From: Chris Bird [REDACTED]
Sent: 07 December 2018 14:42
To: Roger Spencer
Cc: Samantha Allen; Laura Gibbons; [REDACTED]
Subject: Re: Your ref SWS_BREGS_25100 - FAO Phil Davis

GROUND FLOOR PLAN AS PROPOSED WITH SITE + LOCATION PLANS
 2-6, BEACH ROAD, LITTLEHAMPTON
 GRAHAM NICOLLS LTD. BUILDING DESIGN + TECHNOLOGY

I have received a copy of a letter that you sent to Ms S Hoadley of London Building Control, regarding 2-6 Beach Road Littlehampton.

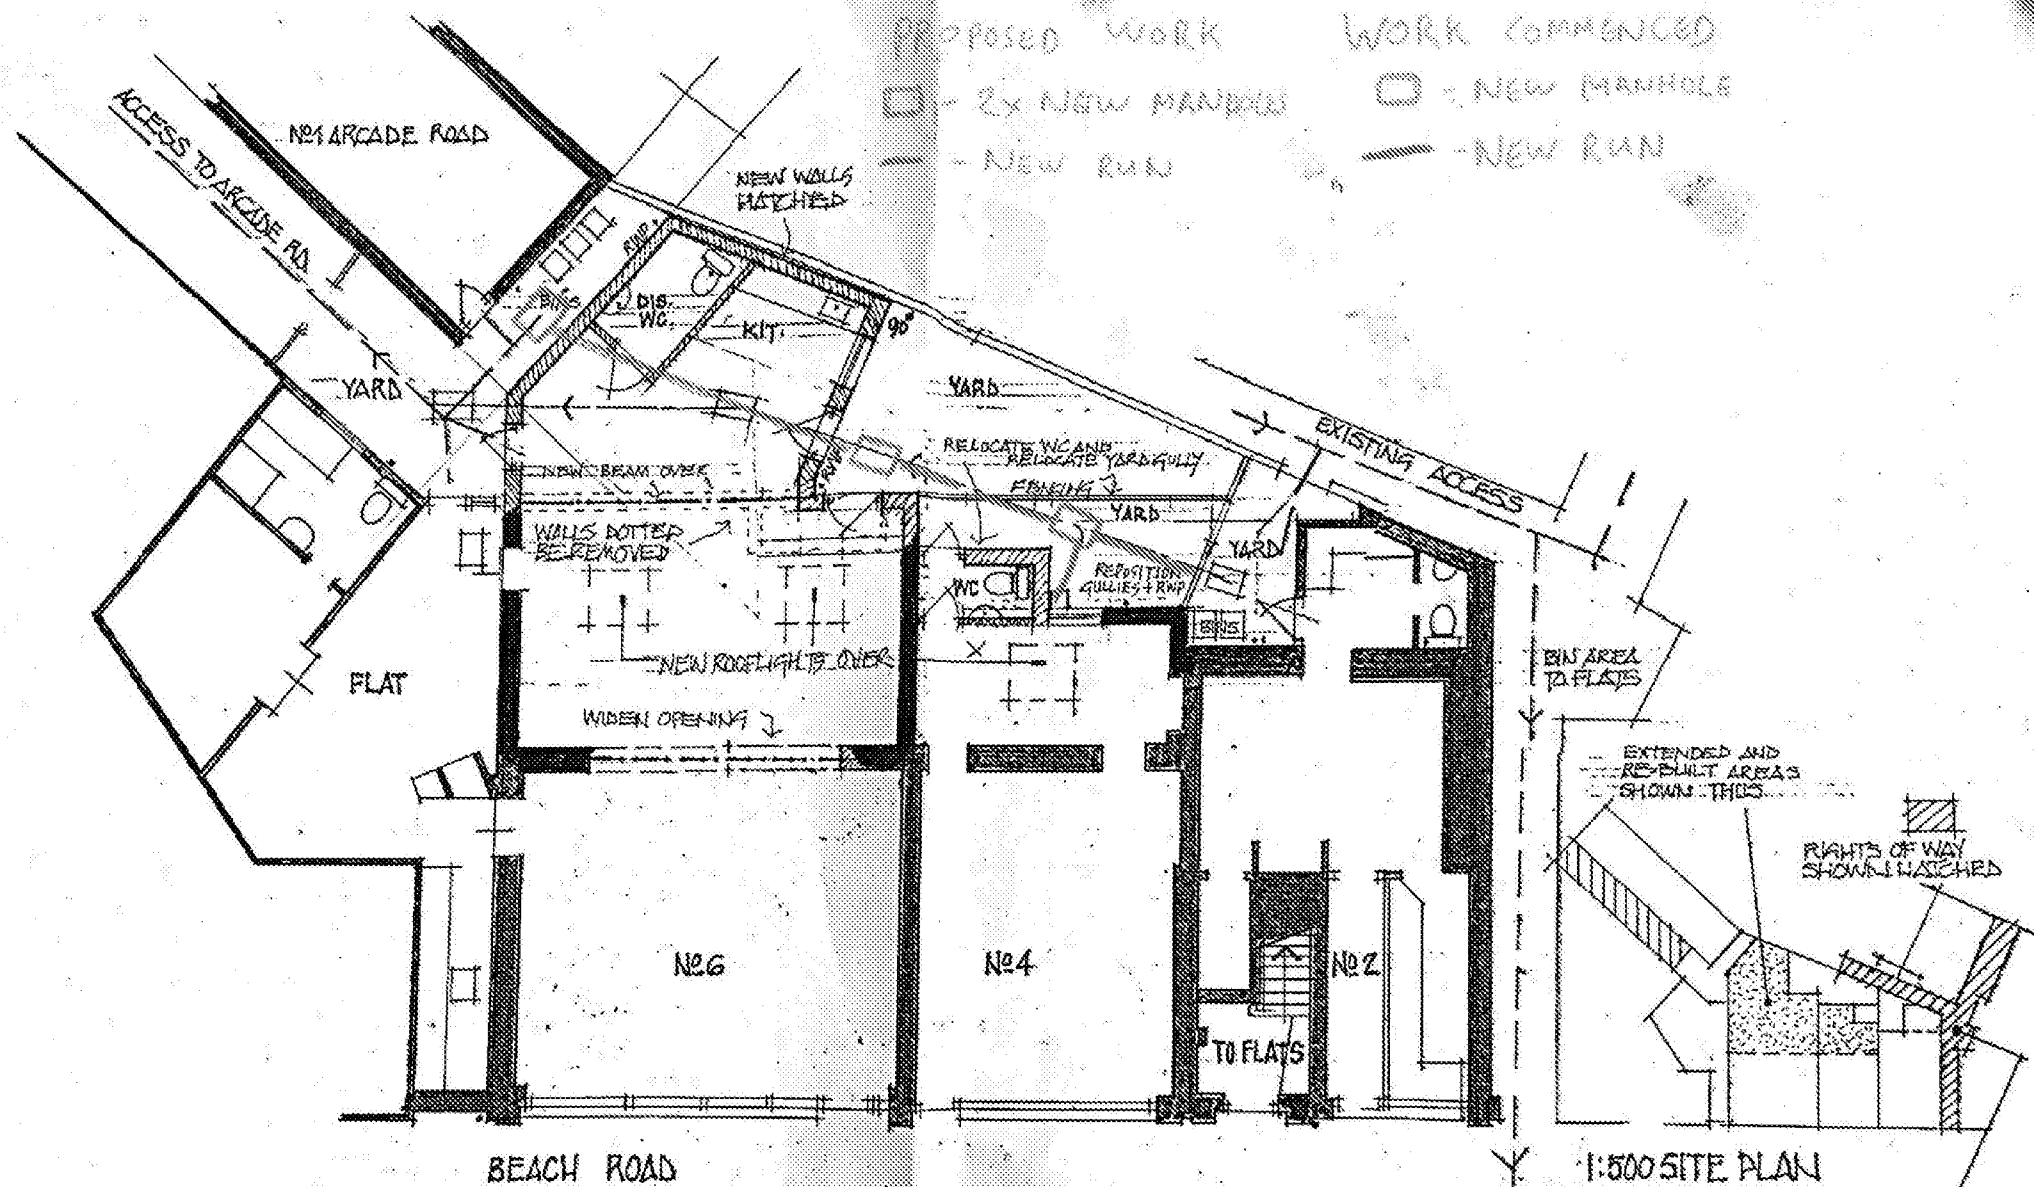
I have attached a plan/pics of what we have done so far and what we propose to do. We had to run a new drain in red on the plan due to the poor condition of the original.

We propose two more manholes as marked on the plans in blue.

The Discharge of Condition Application proposes bolt down covers for a proposed chamber and changing exiting manholes/chamber within the development site to bolt down also.

Are you happy for Arun to discharge this condition with the above proposed solution?
